**From:** Jack Hallam  
**Sent:** 01 April 2019 12:54  
**To:** Ailsa Teasdale  
**Subject:** Planning

Kirkdale Cottage, Egton, Whitby  
YO21 1UT

AMENDED

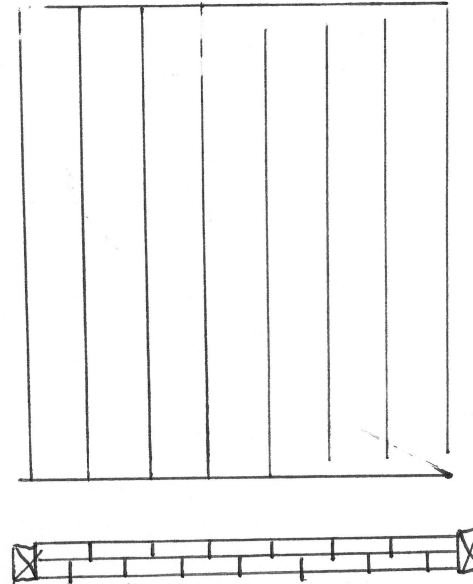
1. Please find enclosed an amended plan. I can confirm that on the basis that the barn can return to its previous lawful use as agricultural/stables should the Joinery business close or move premises then I agree to this element being removed from the application. The reason for including this is to prevent the need to submit any future application for the use of the building to return to its agricultural/stables use.

In addition, I can confirm that the ground floor area on the plan shown as existing stable will be retained as stable until it is required to be extended into buy the joinery business.
